FIVE PONDS WILDERNESS AREA UNIT MANAGEMENT AMENDMENT

High Falls Loop Trail

Proposal

MAP
A

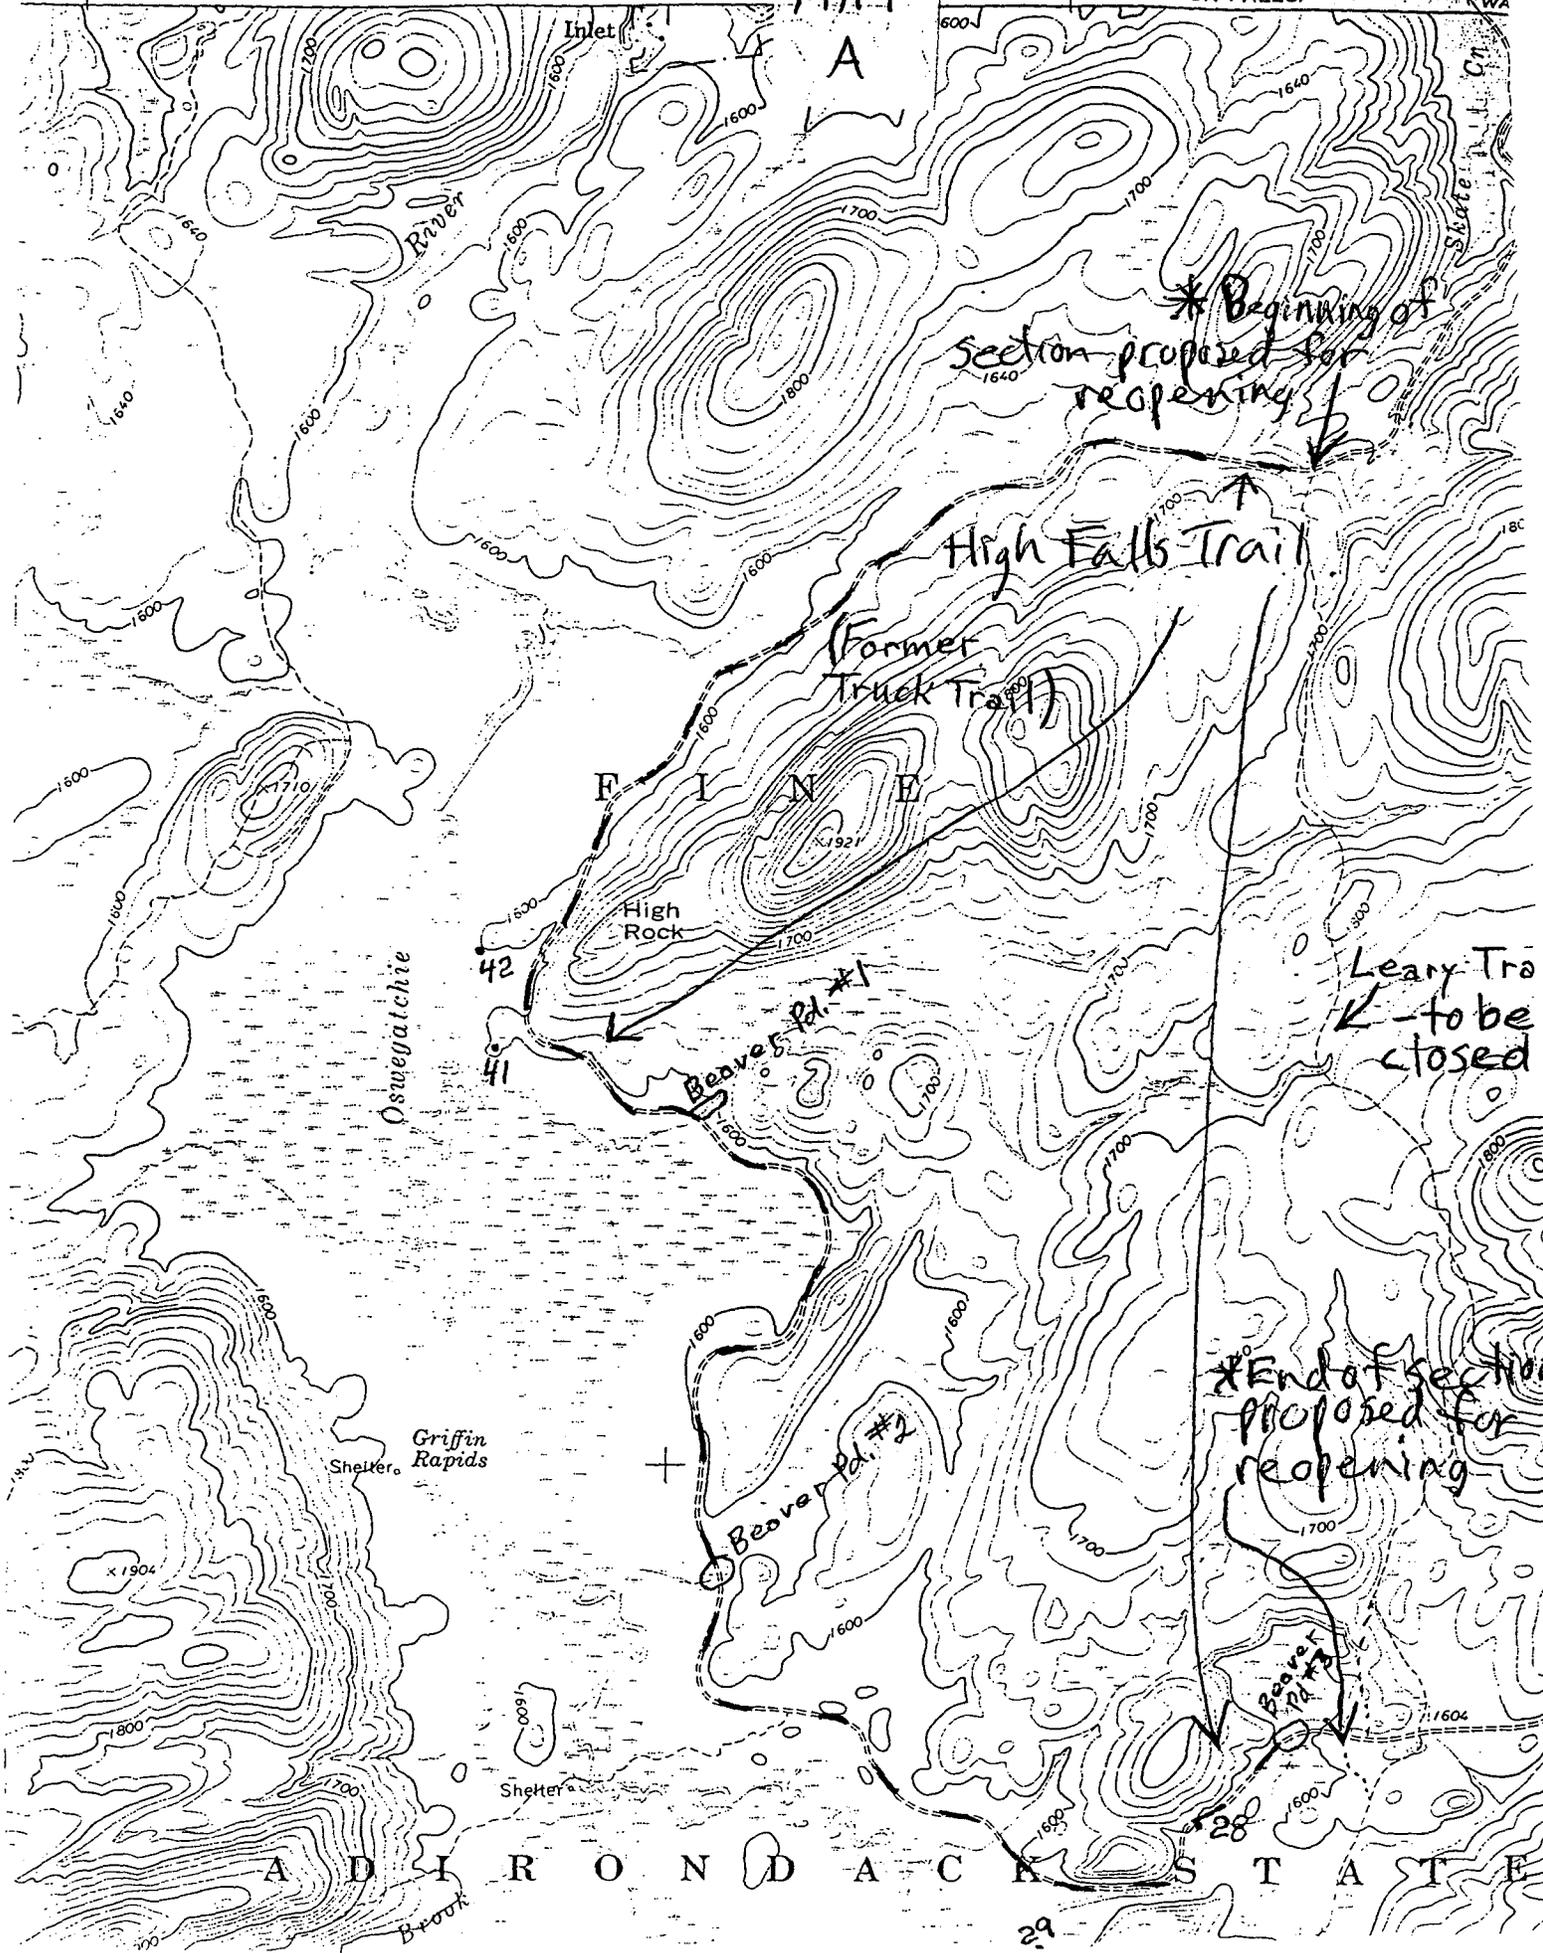
To replace the western part of the High Falls Loop Foot Trail, known as the Leary Trail, with the roadbed of the former High Falls Truck Trail west of the Leary Trail and renamed the High Falls Trail.

At the western end of the High Falls Loop Foot Trail, the first ½ mile of the former High Falls Truck Trail is still being maintained as a road because, as the Wanakena Primitive Corridor, it must be available for this use by the Wanakena Water Company. It has been maintained as a foot trail a short distance further to the beginning of the former Leary Trail and again from the end of this trail to High Falls. The 5.75 mile segment between the ends of the former Leary Trail has not been maintained for many years, and is obstructed by three beaver ponds (see Map A).

- 1) Base - The Leary Trail is located on soils and slopes unable to withstand sustained use as evidenced by 400 feet of mud flat and 374 feet of severe erosion. The former truck trail is hardened for all of this section except for the three beaver ponds which cross it. The first pond will need some minor drytread to protect it and to provide a relatively safe foot crossing along its 114 foot dam, while the others can be easily bypassed.

- 6) Distance - Although the former truck trail is 2.75 miles longer than the Leary Trail, this additional distance is desirable because it would contribute to a 51 mile route around Cranberry Lake (see Map B) when the South Bay Trail is completed (page 43 of Five Ponds UMP attached). This distance is significant to some user groups, such as Boy Scouts, who regularly take trips of this approximate distance.
- 7) Camping - The availability of designated campsites 28, 29, 41 & 42 (see map A) for hiker use will be provided by the use of the former truck trail.
